SUMMARY

GARN® Technical Service Bulletin: Potentially Defective Anode Rods

Figure 6: Place a Bucket/Net Underneath Anode Rod When Removing the Rod

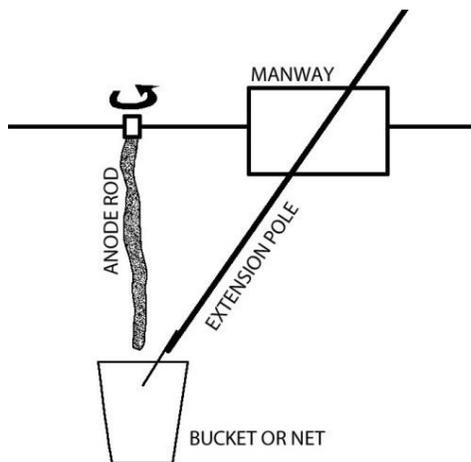
1. When removing the rods, please catch the *slough/debris* that falls off the rod instead of letting the rod debris fall to the bottom of the tank. A simple method for doing this is to buy a pool leaf rake with extension pole from a local retailer and have a helper hold the net underneath the anode rod as it's removed. Another method is to attach bucket to a handle/pole:

Figure 7: Catch the Anode Rod Debris and Remove the Rod

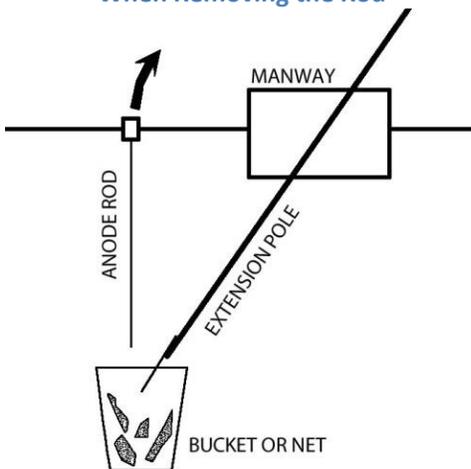
2. After the rods are removed, plug the holes with a $\frac{3}{4}$ " NPT plug. If only the steel core remains on the rod, the rod can be used as the plug.
3. **Remove any and all anode rod debris on the bottom of the tank using the swimming pool leaf rake (or other method).**

Figure 9: White Fluff and Anode Rod Debris on Tank Bottom. Picture taken from manway access after unit was drained

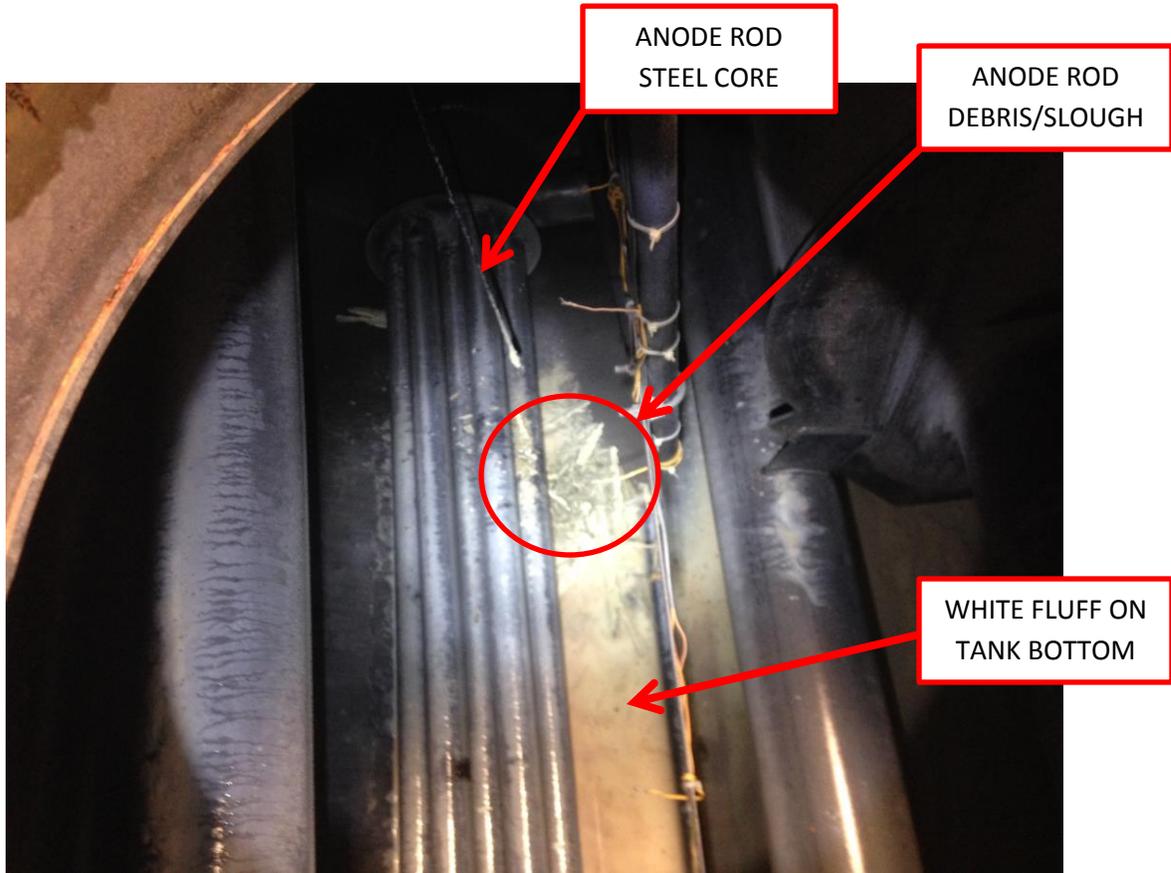
Customers with anode rods exhibiting this issue may experience a white fluff that appears as a "cloud" on the bottom of the tank and on the heat exchanger tubing. For customers that have this condition, Dectra is recommending that the fluff be siphoned out. Use a standard garden hose and wand capable of reaching the problem areas and siphon as much of the fluff out as possible. If needed, top off the unit with filtered, clean fill water from the original fill source.
